ADDENDUM

JLG 24146.01-5 Dunn County Public Safety Center

Issued: November 7, 2025

ADDENDUM #: 02

1
M102
PLUMBING PLAN - LEVEL 1
1/8" = 1'-0"

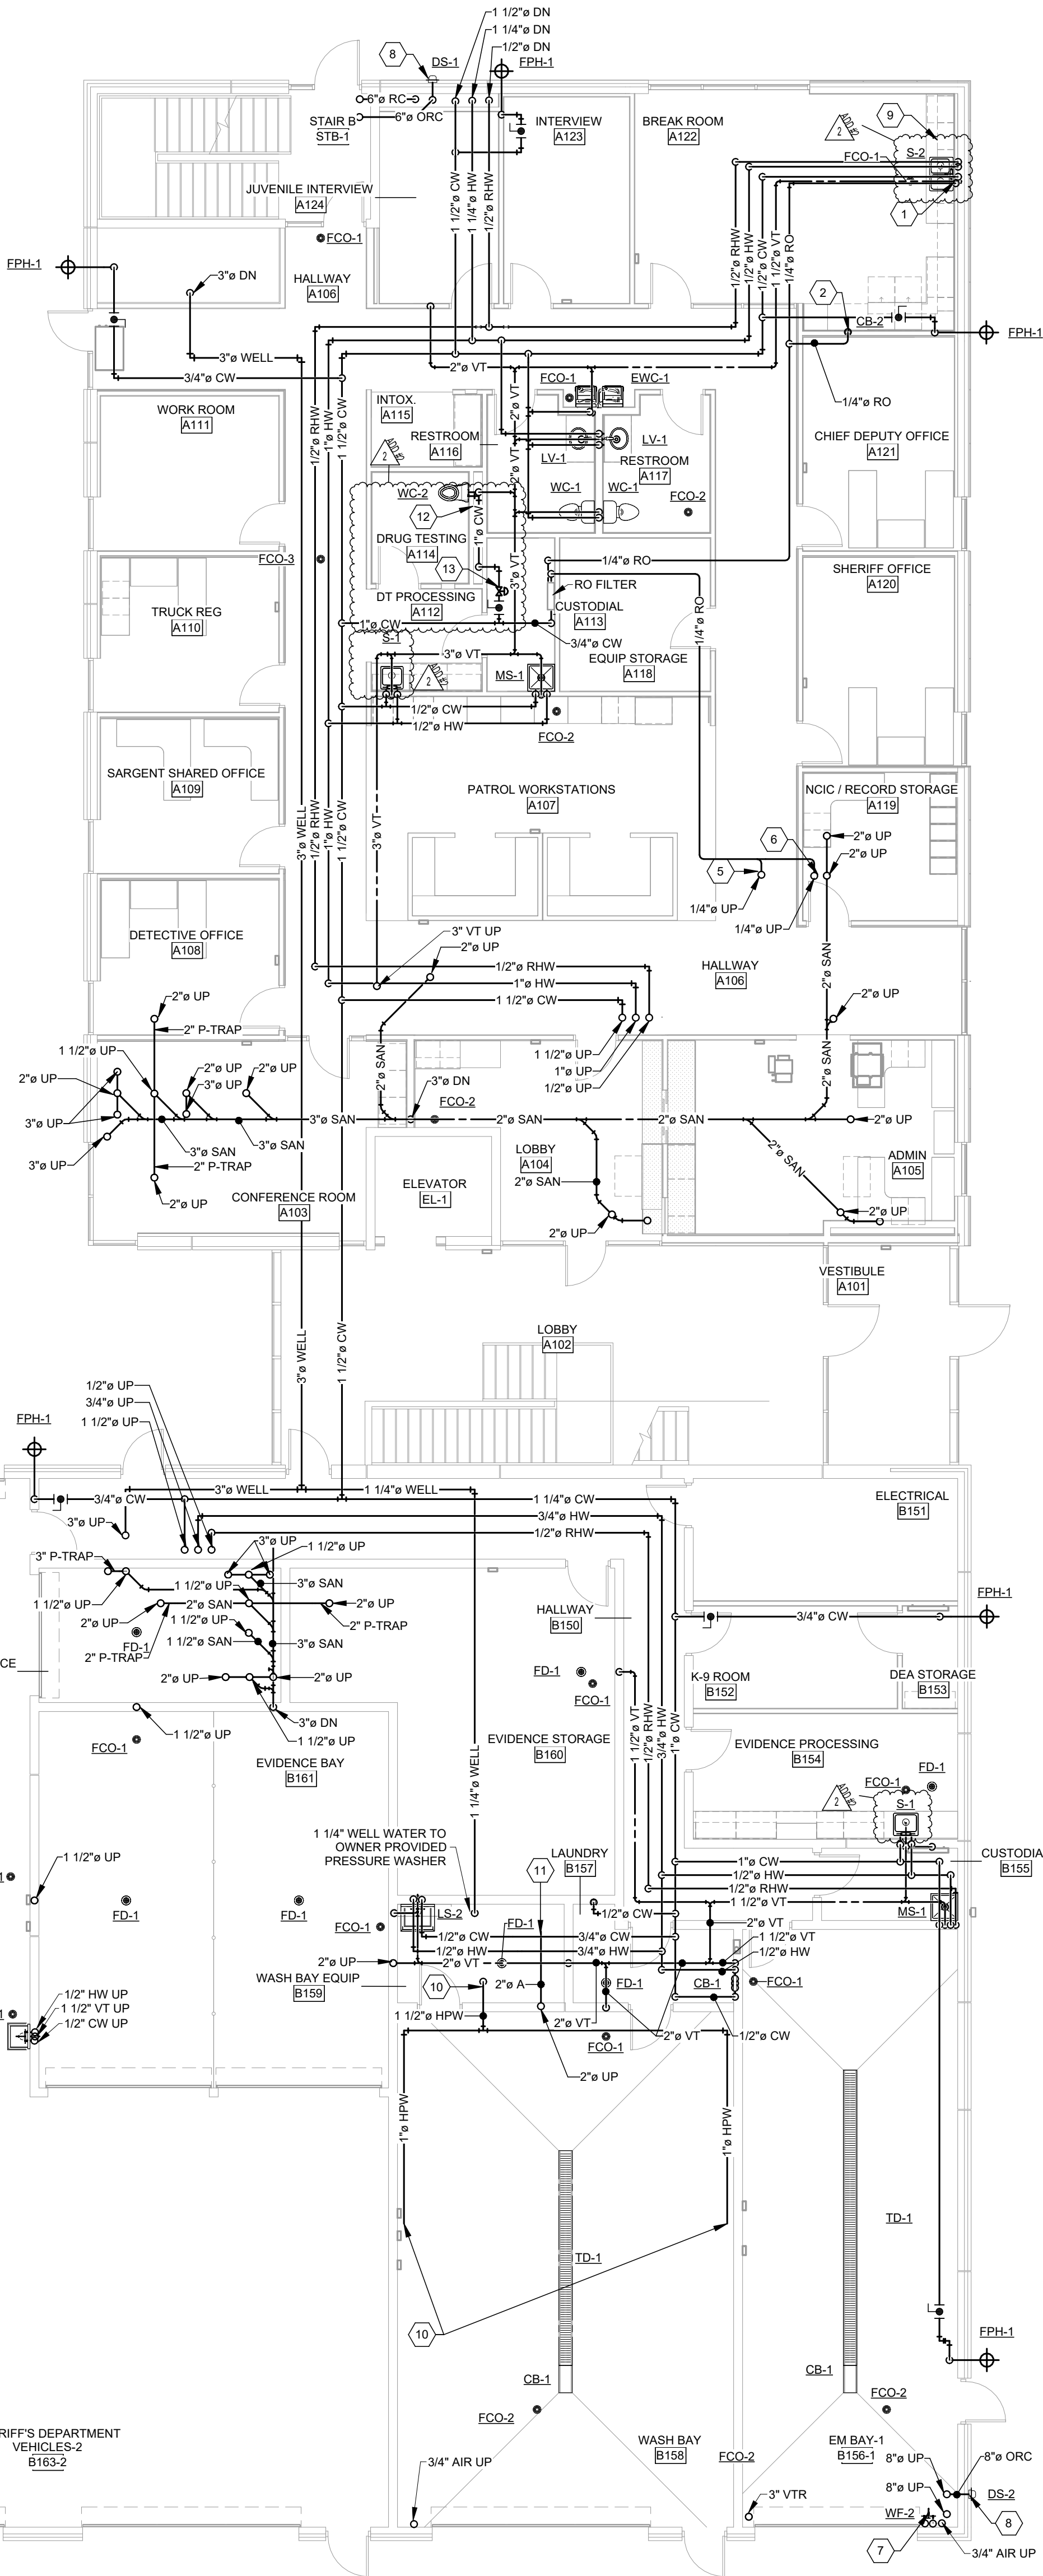
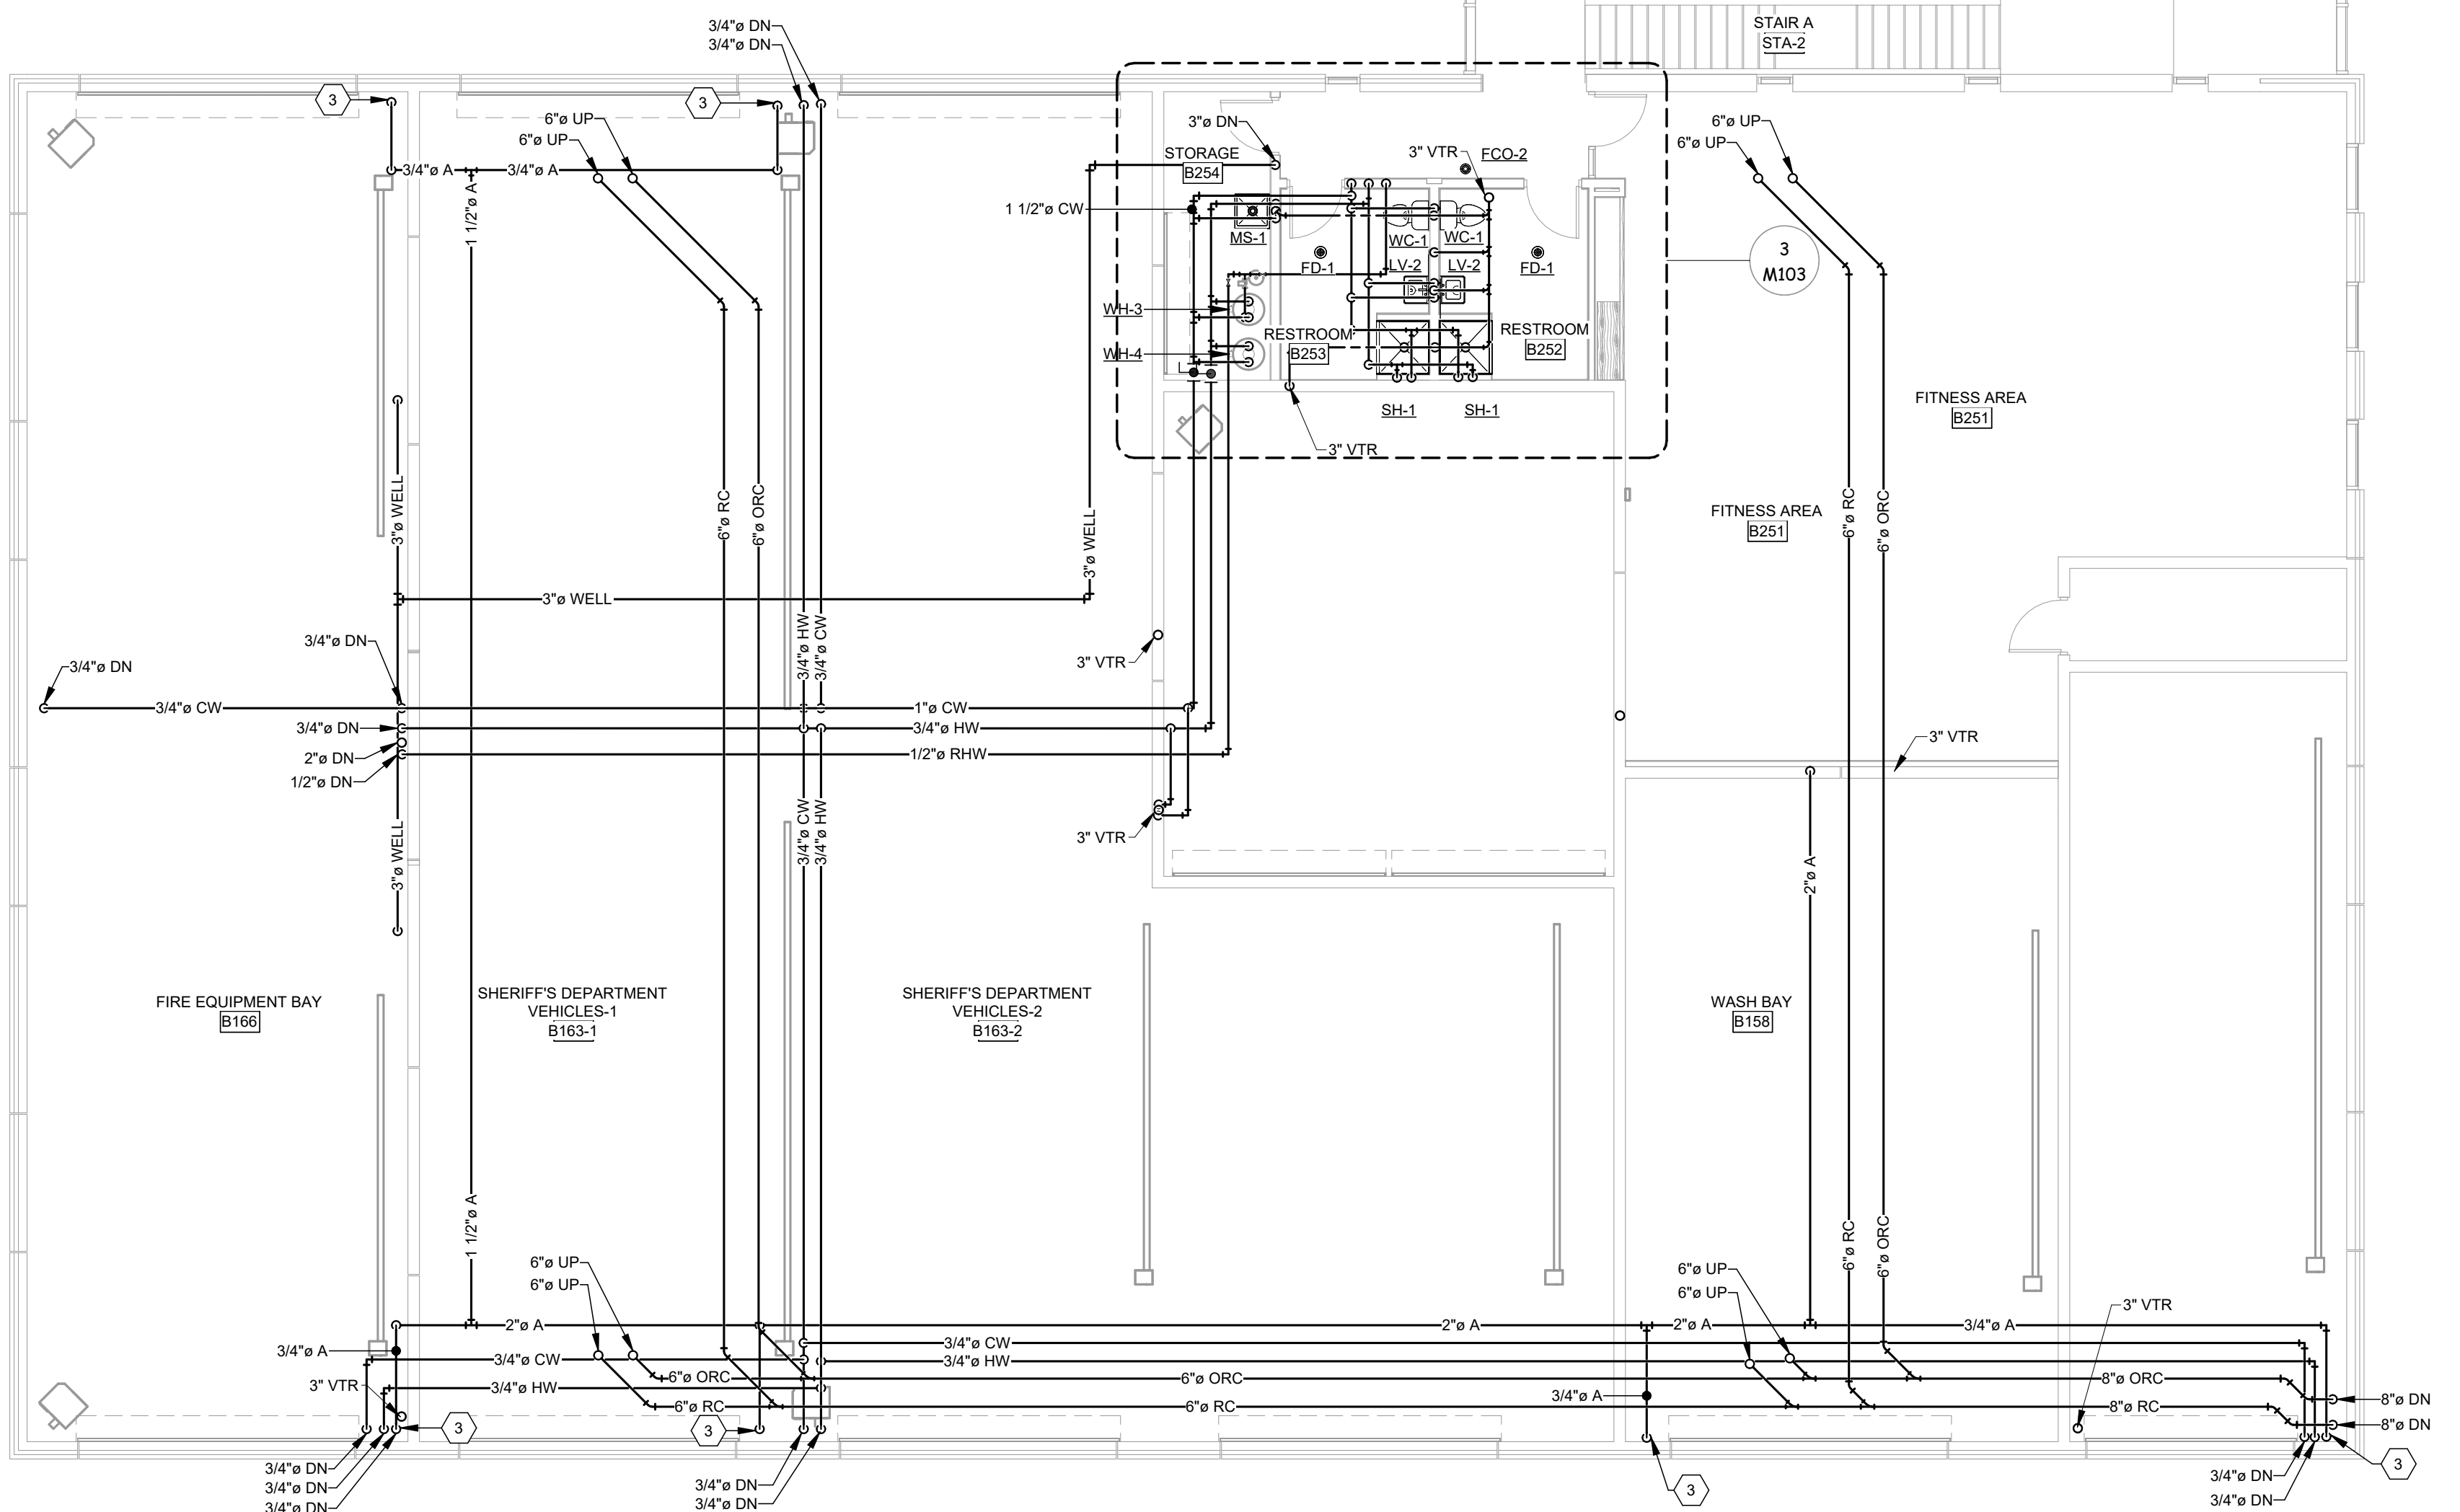
1. M102 – PLUMBING PLANS
 - Provided notes 12 and 13 for concealed valve access panel and solenoid valve for WC-2
 - 1/M102:
 - Reconfigured WC-2 plumbing to add shutoff and solenoid control valves.
 - Renumbered S-1 and S-2 tags after removing single bowl break room sink
 - 2/M102:
 - Renumbered S-1 and S-2 tags after removing single bowl break room sink
2. M302 – MECHANICAL PLANS
 - 2/M302:
 - Provided return grille from hallway to ceiling plenum space
 - Shifted return duct south of hallway door
 - Provided motorized dampers on return ducts for smoke control in atrium space
3. M404 – MECHANICAL SCHEDULES
 - Replaced laundry sink LS-2 with black sink and provided trim selection.
 - Replaced S-1 and S-2 with ADA compliant models.
 - Replaced WC-2 with model Z5617-BWL
 - Replaced WC-2 trim with model Z6152 concealed flush valve
